Adaptable & Livable Apartments

| CURRENT REVISION COMMENTS | | |
|--|-------------------------|----------|
| 5 | Development Application | 13.07.18 |

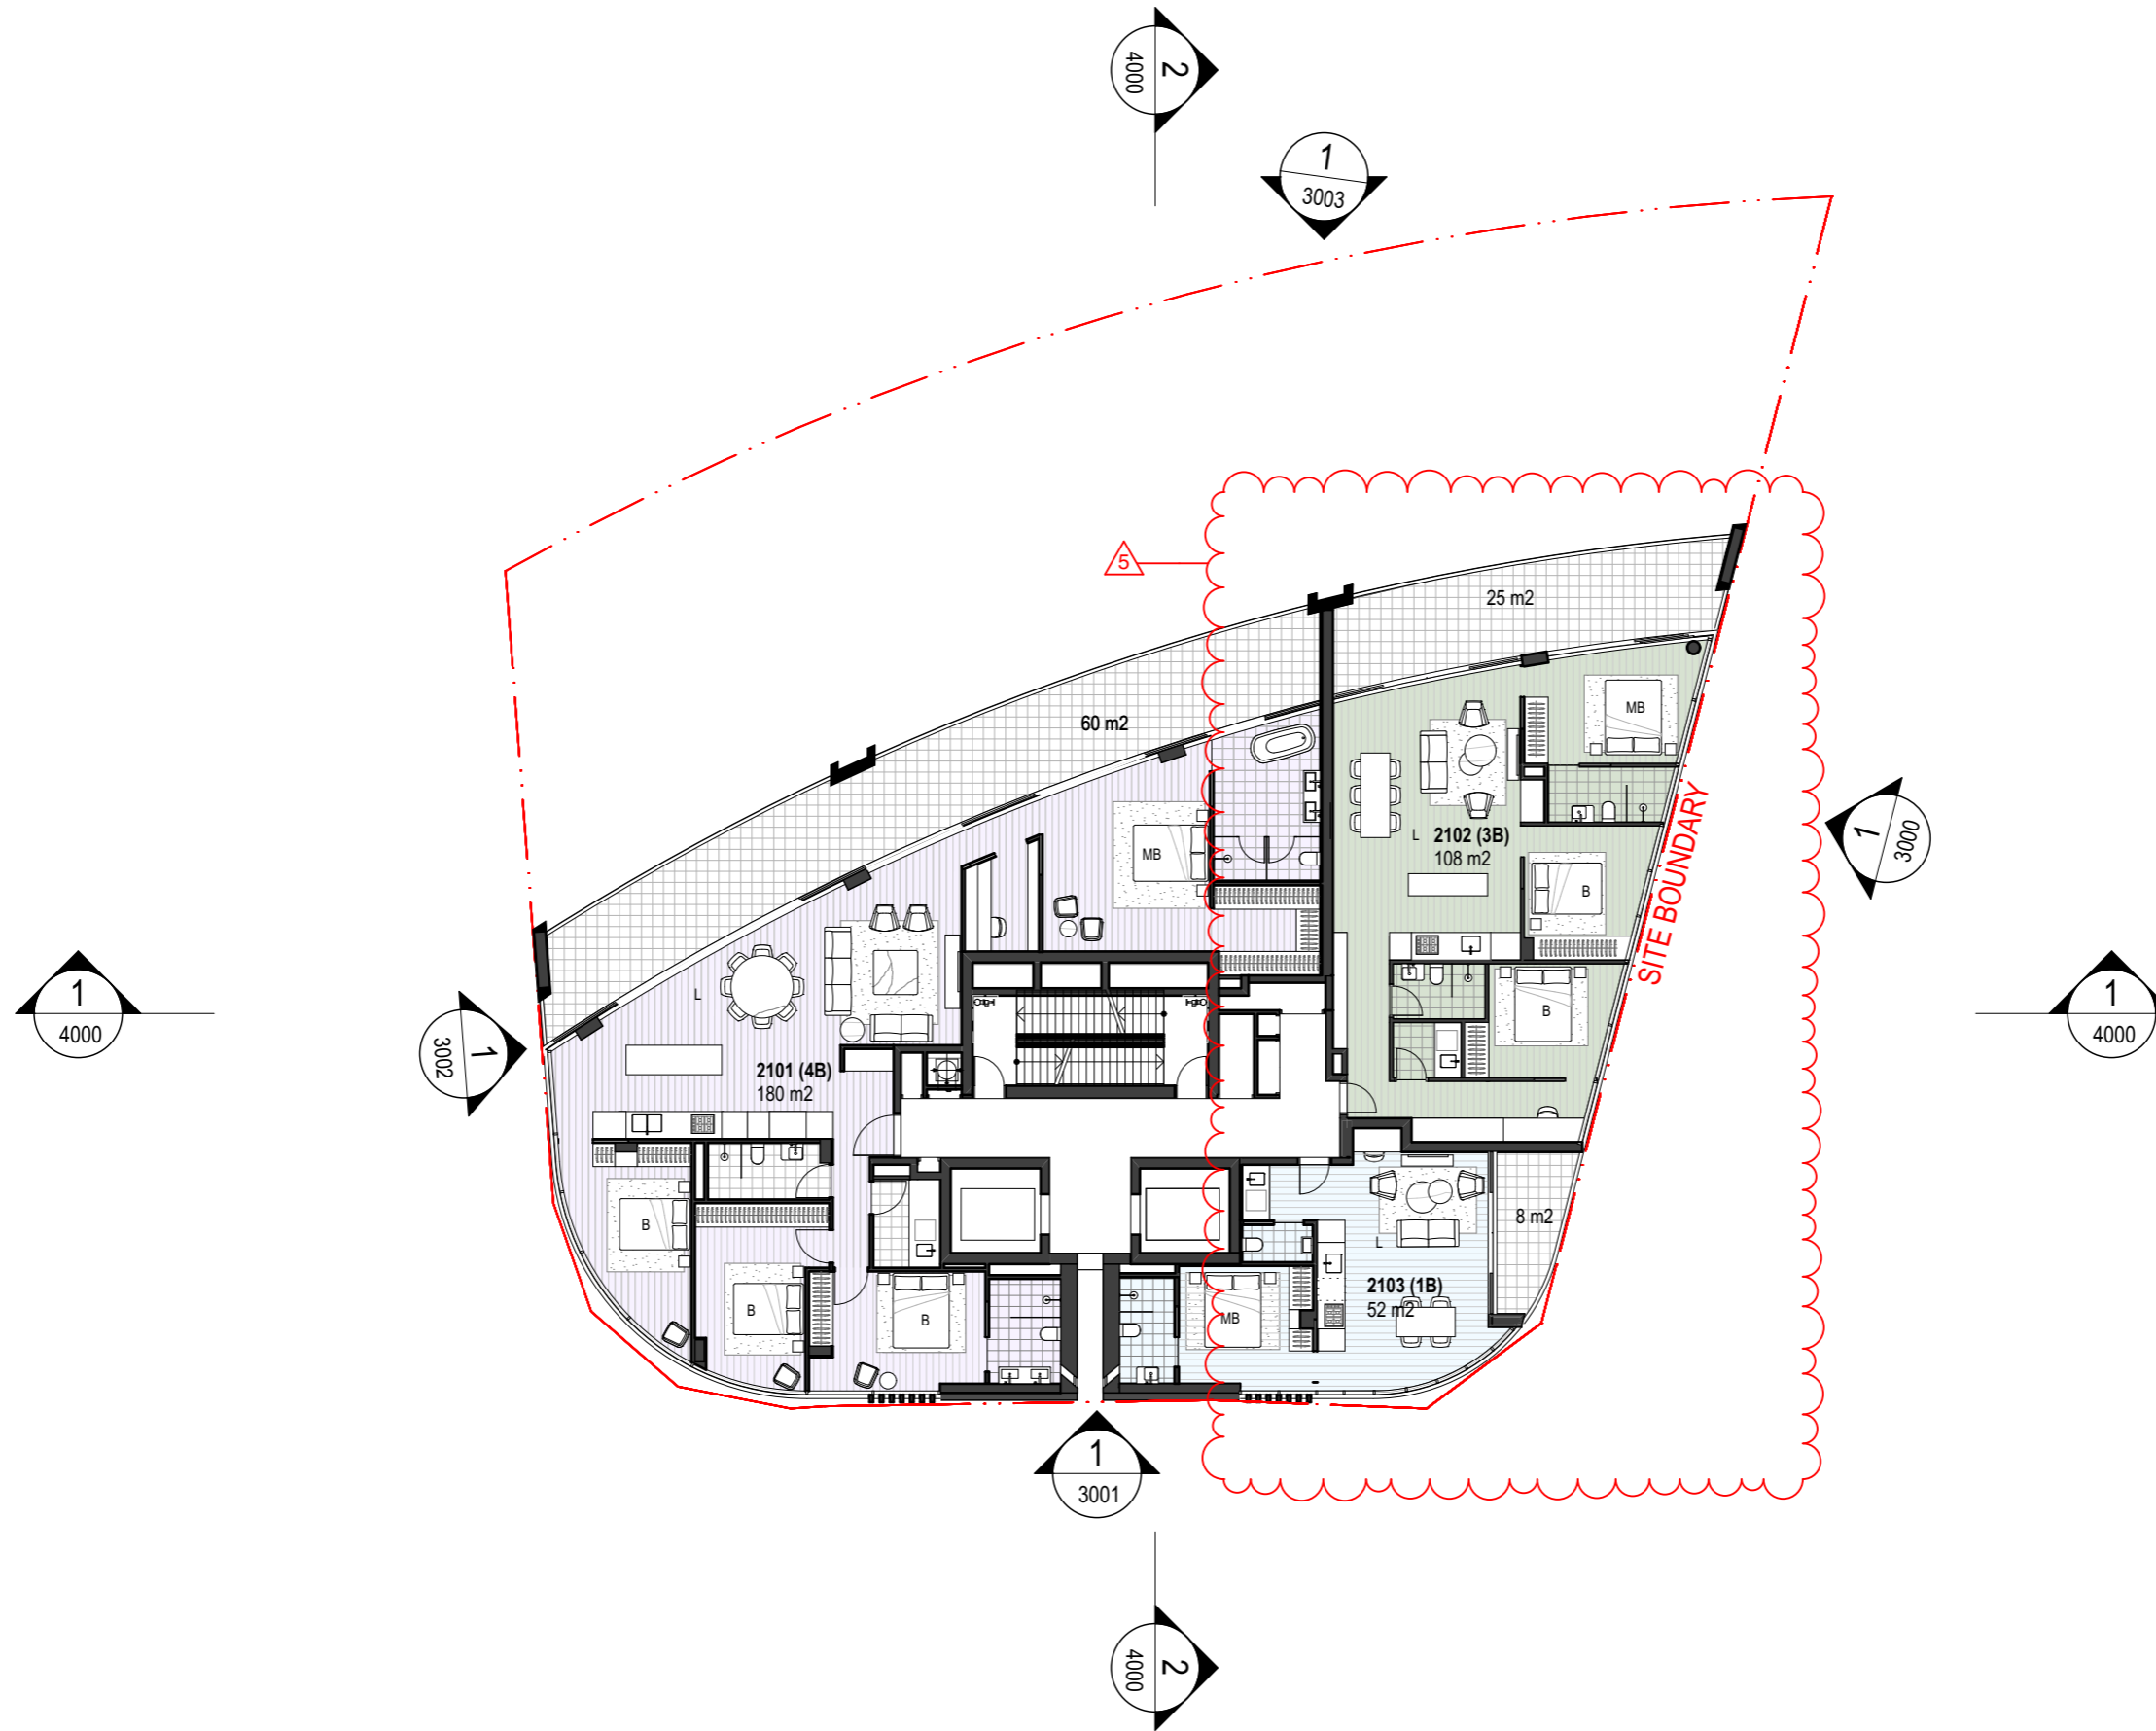
| CURRENT REVISION COMMENTS | | |
|--|-------------------------|----------|
| 1. LEVEL 20 INTERNAL LAYOUT CHANGED TO 3x3B AND 1x2B | | |

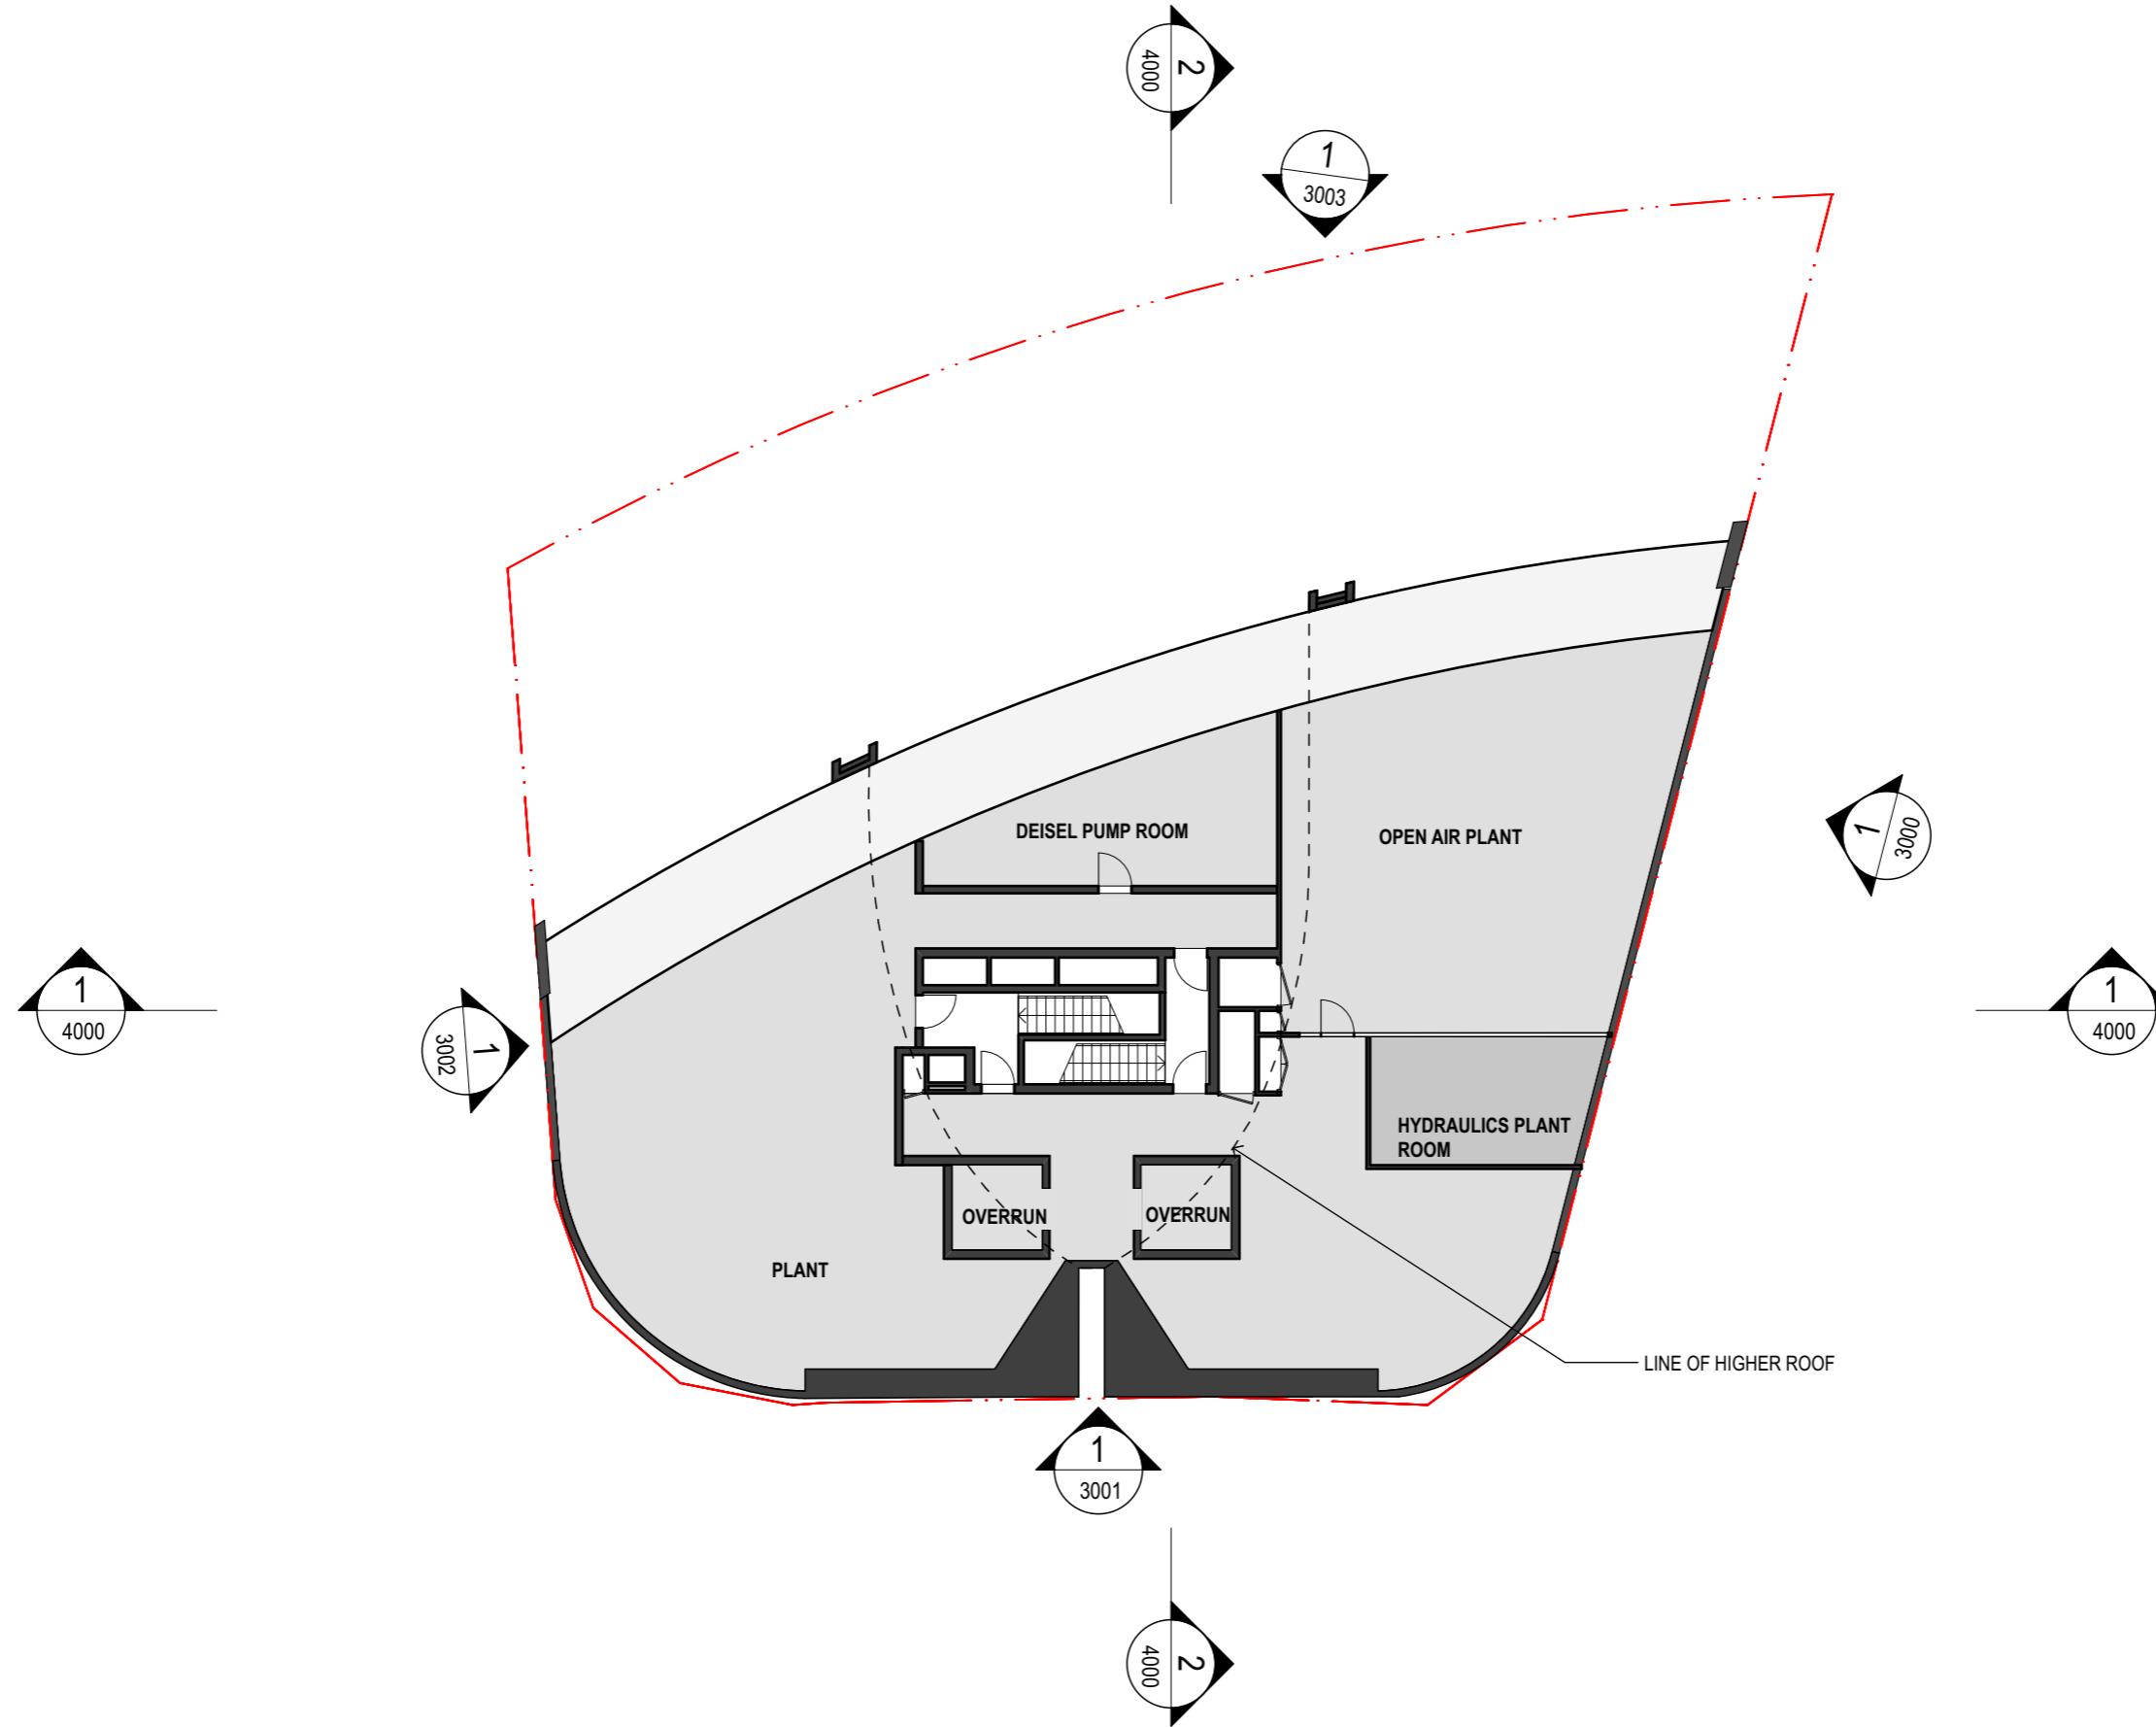
| CURRENT REVISION COMMENTS | | |
|--|-------------------------|----------|
| 1. LEVEL 21 INTERNAL LAYOUT CHANGED. UNIT 2102 CHANGED TO 1x3B AND 1x1B. UNIT 2101 HASN'T CHANGED. | | |

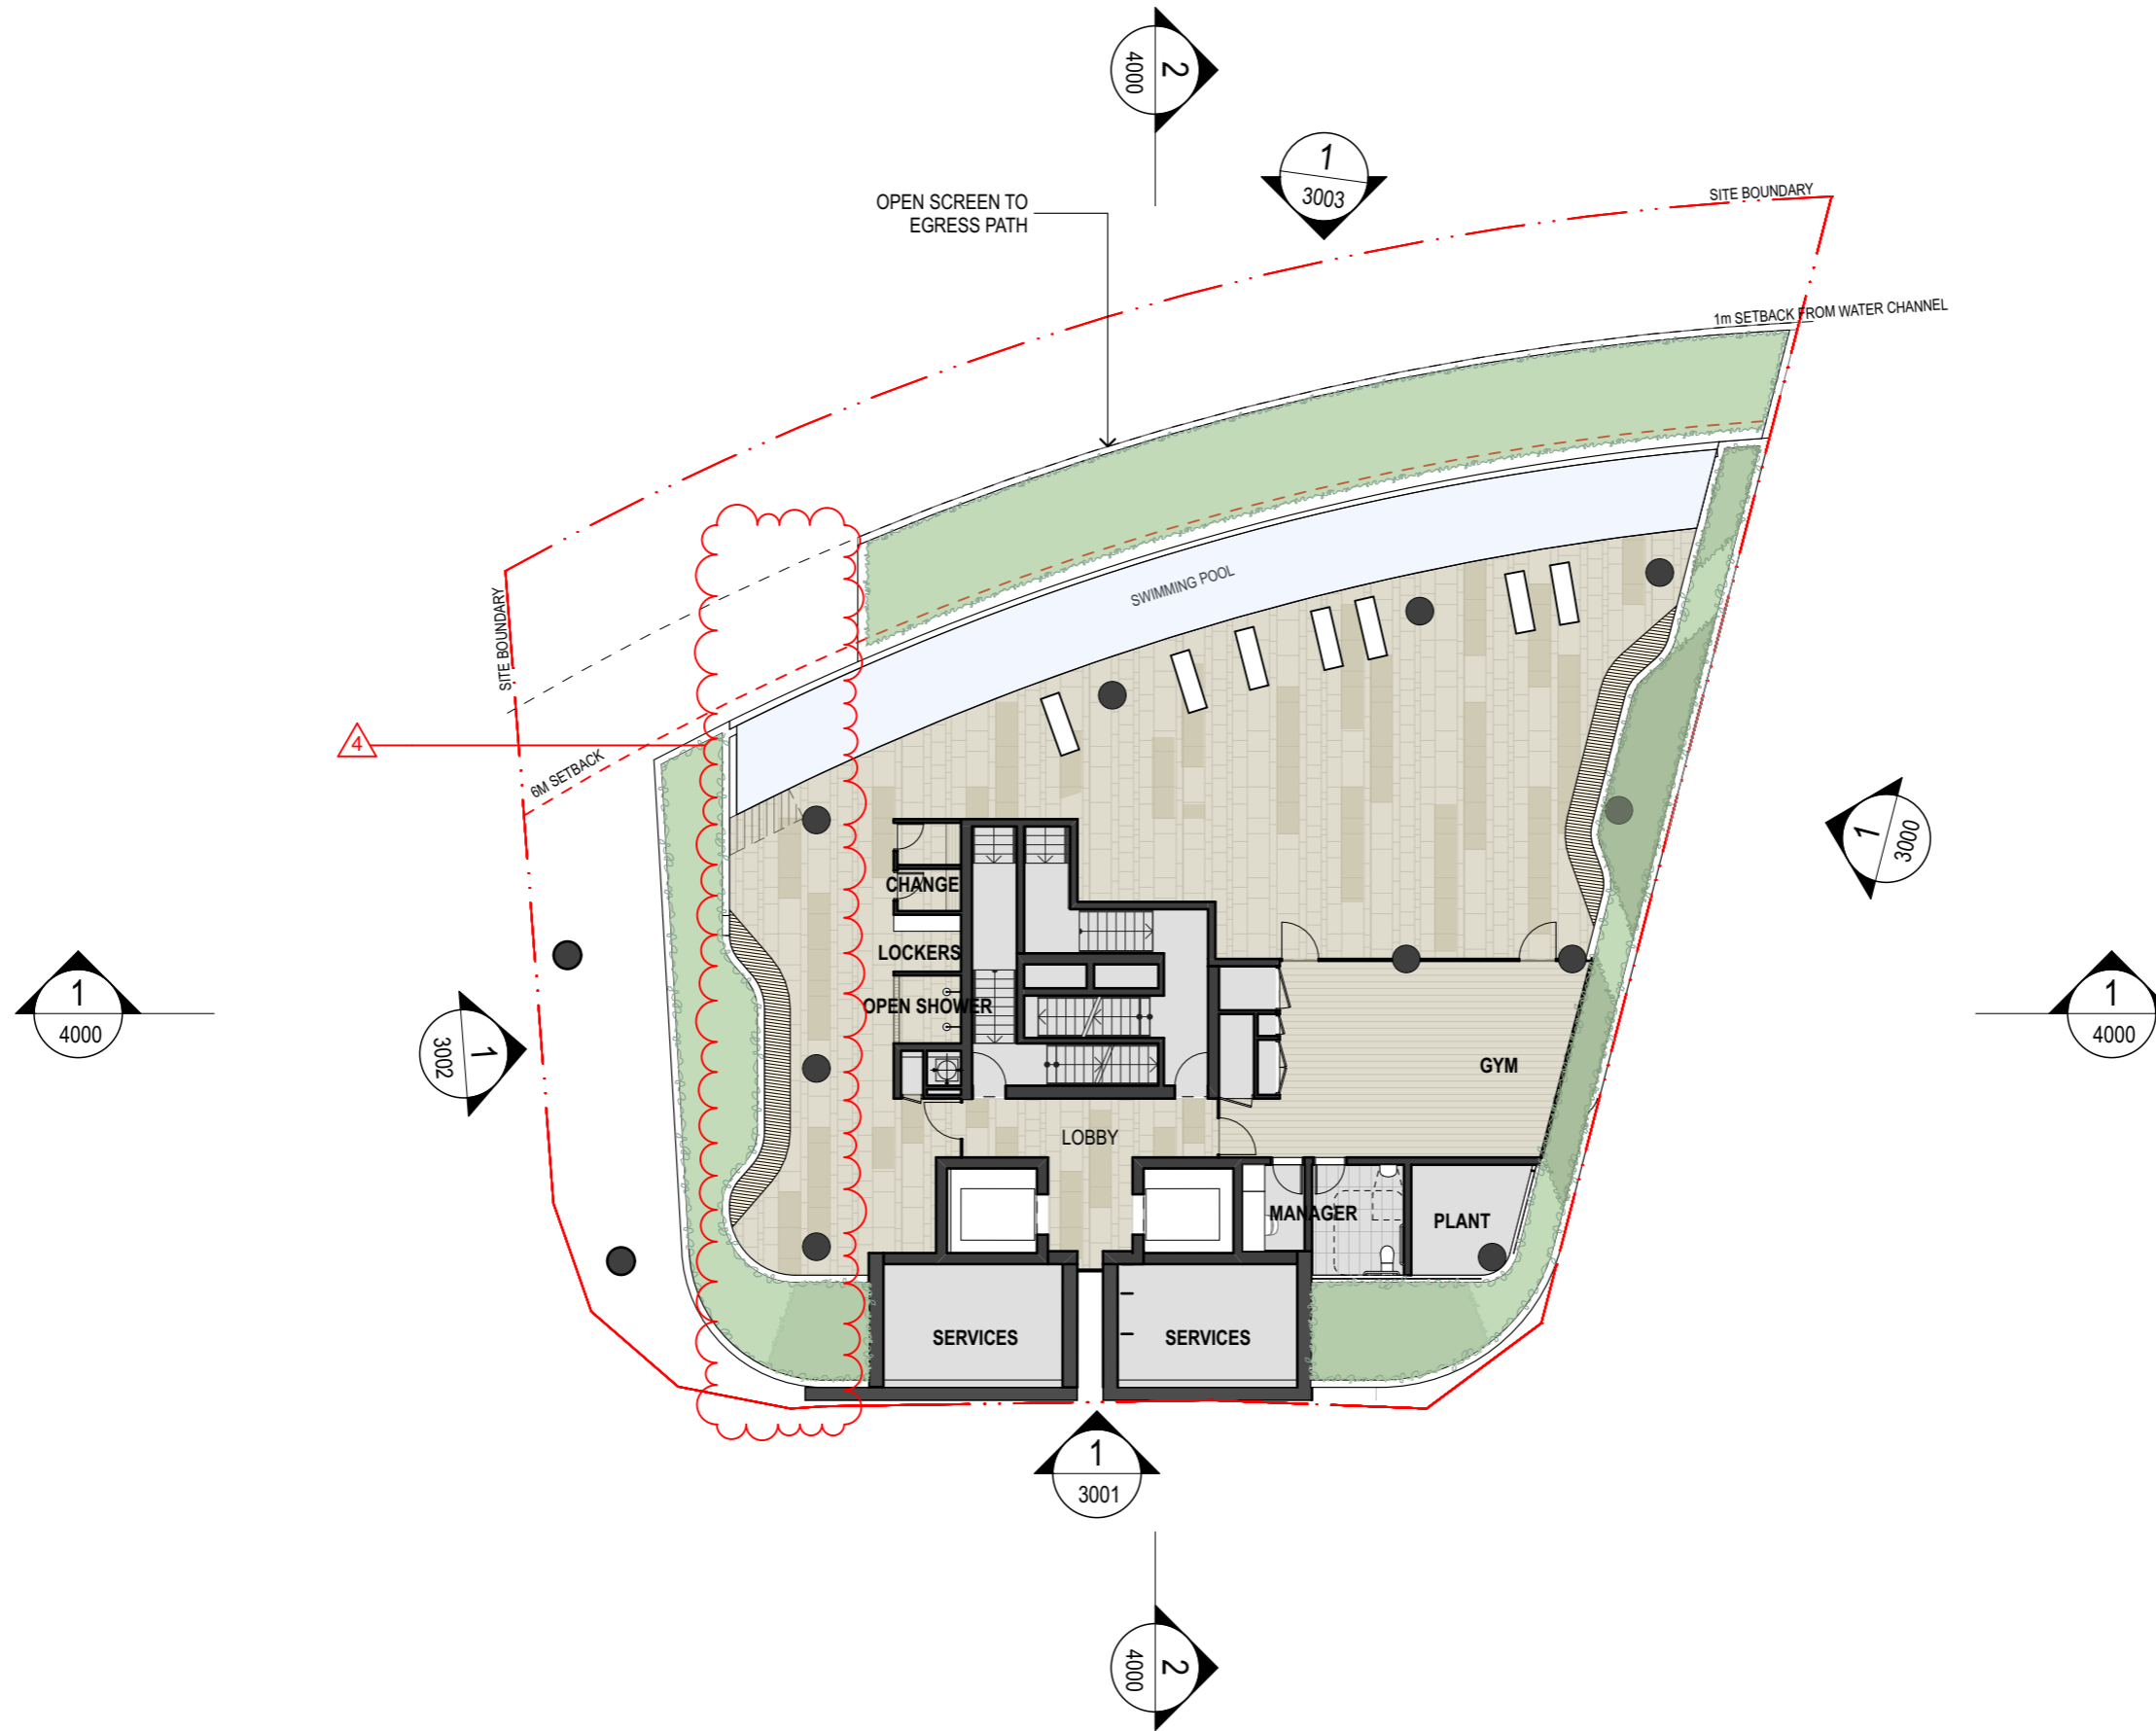
| CURRENT REVISION COMMENTS | | |
|---|-------------------------|----------|
| 1. COLUMNS RELOCATED TO MATCH NEW LOCATION IN GROUND FLOOR. | | |
| 2. SUBSTATION RELOCATED IN GROUND FLOOR | | |
